DEPARTMENT OF THE NAVY

**SUBJECT: RISK AND VULNERABILITY ASSESSMENT FOR THE RED HILL
ADMINISTRATIVE ORDER ON CONSENT ("AOC") STATEMENT OF
WORK ("SOW") SECTION 8**

Red Hill Bulk Fuel Storage Facility
Administrative Order on Consent Section 8.3

**Navy's Risk and Vulnerability
Assessment Summary**

Figure 1

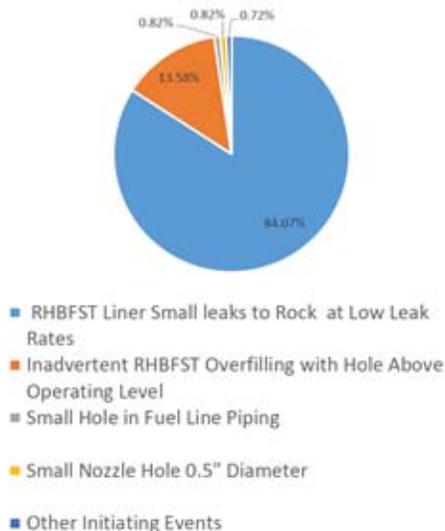
While the above concerns may or may not have an impact on the absolute values presented in the Phase 1 Report, individual risks can still be compared on a relative basis. *Figure 1* shows that based on frequency, initiating events related to the steel tank liner account for 98% of sequences resulting in a release (84% Liner Leaks + 14% Overfill). However, based on a significant release volume of 120,000 gallons or more, the initiating events related to the nozzle are 5 times that of the steel liner in *Figure 2*.
